Contract #: 04-0120F4Cty: SF/ALA Rte: 80 PM: 13.2/13.9File #: 69.25B

QUALITY ASSURANCE -- NON-CONFORMANCE REPORT

Reference Description: Unapproved Heat Straightening of Deck Plate Diaphragm**Description of Non-Conformance:**

Subject: NCR No. ZPMC-0659

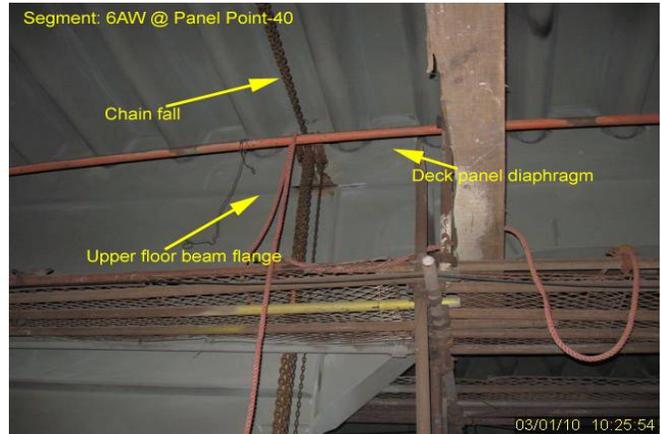
- ZPMC personnel have performed heat straightening at various locations along the top flange of the Floorbeam and the Deck Plate Diaphragm at Panel Point (PP) 40 in OBG segment 6AW.

- Heat Straightening work performed by ZPMC personnel deviated from the procedure shown on HSR1(B)-8155. Heat signatures were observed on the Deck Plate Diaphragm and the top flange of the Floorbeam. The internally approved HSR1 detailed heat straightening to be performed on the top flange of the Floorbeam only.

- HSR1(B)-8155 denotes heat straightening of up to 25mm.
- Not all locations which received heat straightening were identified in HSR1(B)-8155.
- The jack used during heat straightening was not positioned as detailed in the HSR1.

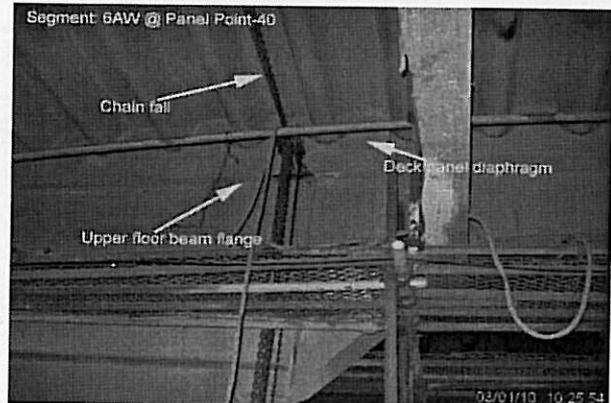
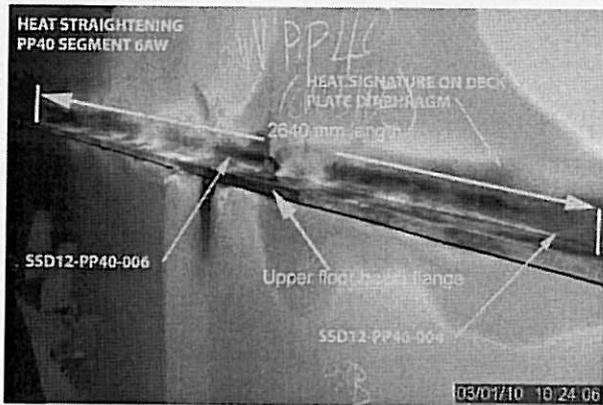
- ZPMC personnel have performed heat straightening at various locations along the top flange of the Floorbeam and the Deck Plate Diaphragm at Panel Point (PP) 40 in OBG segment 6AW.

- Heat Straightening work performed by ZPMC personnel deviated from the procedure shown on HSR1(B)-8155. Heat signatures were observed on the Deck Plate Diaphragm and the top flange of the Floorbeam. The internally approved HSR1 detailed heat straightening to be performed on the top flange of the Floorbeam only.

- HSR1(B)-8155 denotes heat straightening of up to 25mm.
- Not all locations which received heat straightening were identified in HSR1(B)-8155.
- The jack used during heat straightening was not positioned as detailed in the HSR1.

<h2 style="text-align: center;">火工校正记录</h2> <h3 style="text-align: center;">Heat Straightening Record(HSR1)</h3>	报告号 Record#	HSR1(B)-8155
	版本号 Revision #	0
	日期 Date	2010.02.27

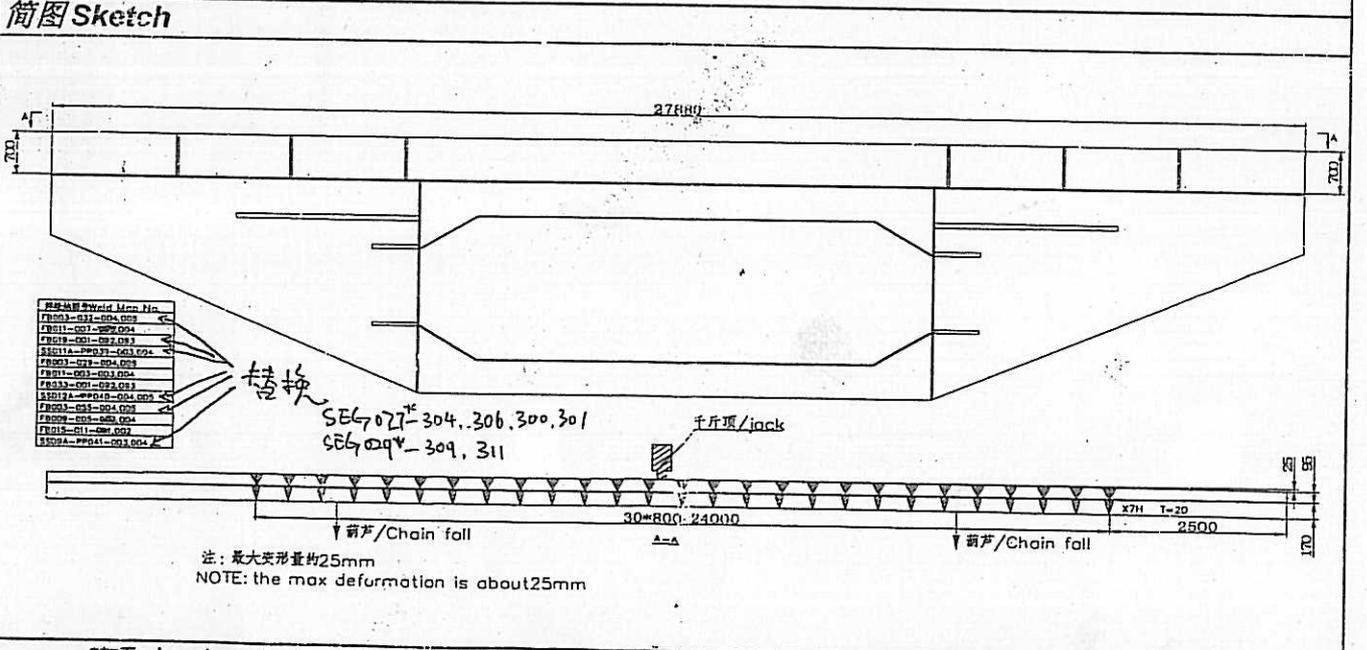
Please provide a description of what actions will be taken to prevent this non-conformance from occurring in the future. Additionally, please provide a description of the actual methods used during heat straightening as the methods used were not in accordance with the HSR1. Also, the NDT provided with this NPR cannot be verified as updated weld maps have not been provided showing changes from fillet welds to CJP welds. Additionally, weld maps for SEG027* and SEG029* have not been provided to verify the applicability of the NDT results provided.

ZPMC is providing the HSR1 and sequent NDT records show the acceptable of these welds after heat straightening. Please be noticed that the welds' ID identified in NCR are incorrect, the fillets between Deck panel diaphragm & Floor beam flange have been changed into CJP joints, and the welds on FB were mis-located. Please check the attached report for correct information. Based on this, ZPMC is requesting closure of this NCR.

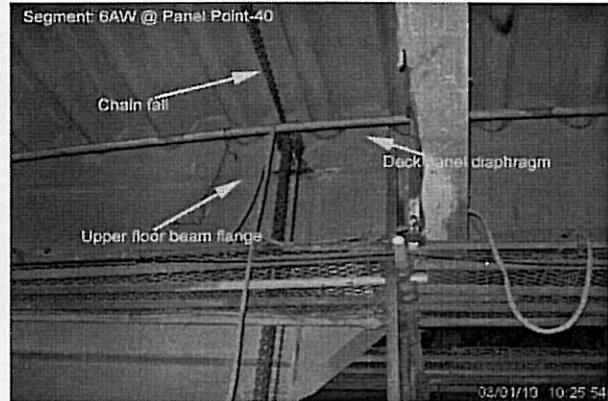
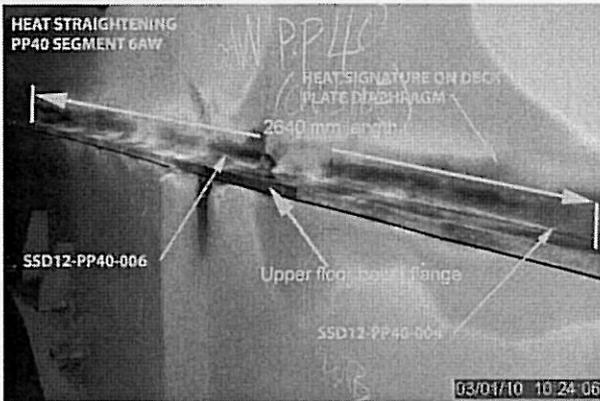
-ZPMC personnel have performed heat straightening at various locations along the top flange of the Floorbeam and the Deck Plate Diaphragm at Panel Point (PP) 40 in OBG segment 6AW.

-Heat Straightening work performed by ZPMC personnel deviated from the procedure shown on HSR1(B)-8155. Heat signatures were observed on the Deck Plate Diaphragm and the top flange of the Floorbeam. The internally approved HSR1 detailed heat straightening to be performed on the top flange of the Floorbeam only.

-Not all locations which received heat straightening were identified in HSR1(B)-8155.

-The jack used during heat straightening was not positioned as detailed in the HSR1.

报告号 Record# HSR1(B)-8155
 版本号 Revision # 1
 日期 Date 2010.02.27

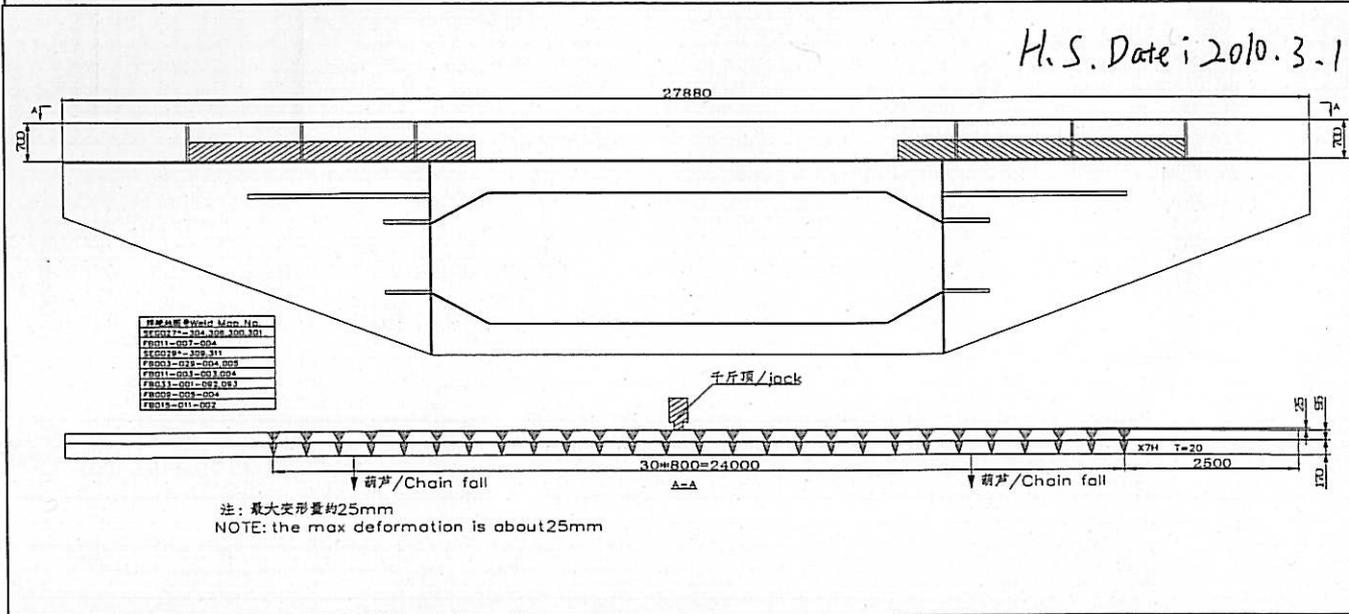
1. the locations of the added temporary welds are not shown on the revised HSR1.
2. not all the weld maps supplied are applicable to the repair locations or the piece marks and weld numbers listed in the NCR.
3. NDT records for the welds listed in the NCR have not been submitted completely.

ZPMC has revised the HSR to reflect all areas observed being heat straightened. In addition, updated weld maps which shot the fillet welds which were turned into CJP welds have been attached as well as other requested weld maps from ZPMC. ZPMC QA has issued an internal NCR and advised to Technical Department to provide more detailing when issuing HSRs to prevent this from occurring again. Based on these actions, previously submitted NDT reports which show the affected welds are acceptable and that this work item was removed from the punchlist prior to shipment, ZPMC requests closure of this NCR.

ZPMC acknowledged this issue and has written an internal NCR. As talked with ZPMC technical department, the future HSR1s will be issued with more detail method what will be used in field. And will be available to department's inspector to review. This issue has been rectified before the loading of OBG shipment 2. The relevant item has been verified and removed from punchlist by department's representative. ZPMC is providing the revised HSR1 and weld maps show the detail method what ZPMC used of this rectification and the affected locations. Based on this, please consider closure of this NCR.

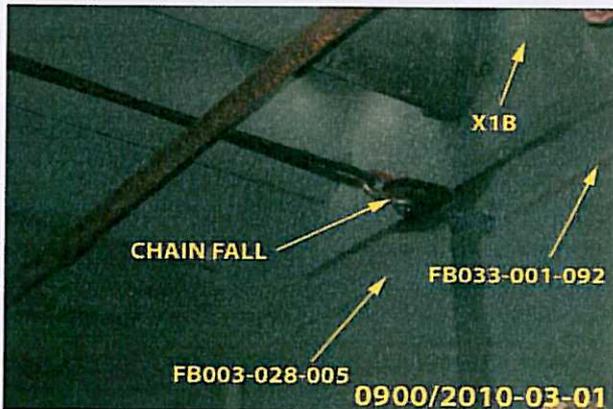
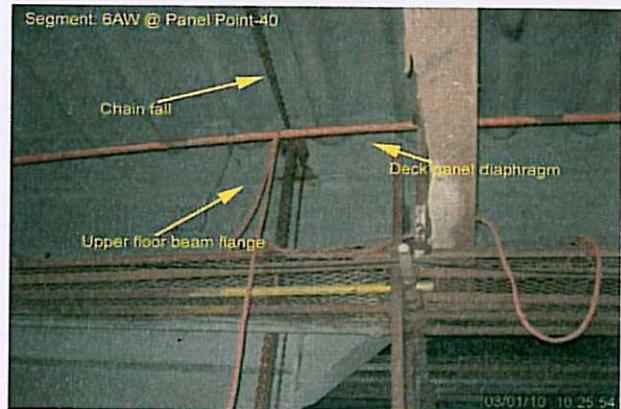
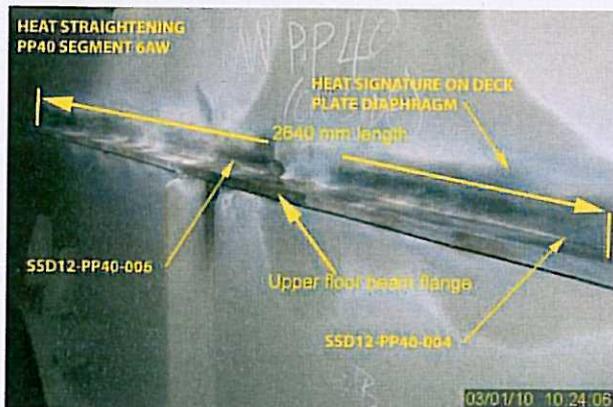
-The piece marks of the affected Floorbeams at PP40 are as follows: FB011-003, FB003-028, FB033-001. The piece mark of the Deck Plate Diaphragm at PP40 is X1B.

-The Deck Plate Diaphragm is 716mm tall and 14mm thick.

-The weld numbers for the affected welds at PP40 are as follows: SSD12-PP040-005, SSD12-PP040-006, SSD12B-PP040-003, FB003-028-004, FB003-028-005, FB011-003-003, FB011-003-004, FB011-003-044, FB033-001-092, FB033-001-093, and FB033-001-147.

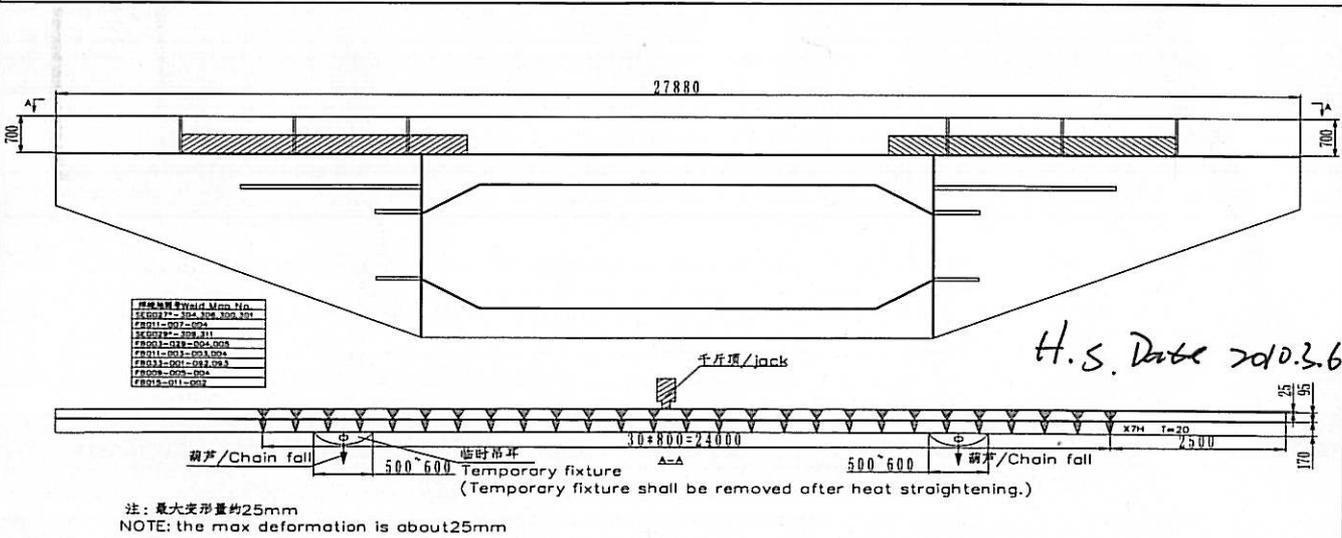
Provide an updated HSR1 detailing work that was performed in the field.

Reference Resolution: ZPMC is submitting the HSR with the revised date which shows the changes made occurred on 7/15/2010.

ZPMC is submitting the HSR with the revised date which shows the changes made occurred on 7/15/2010. The work referenced on the HSR still took place on 3/3/2010 but the revisions of the HSR required for closure of this NCR were done subsequently. Based on this revisions and previously submitted acceptable NDT results, ZPMC requests closure of this NCR.
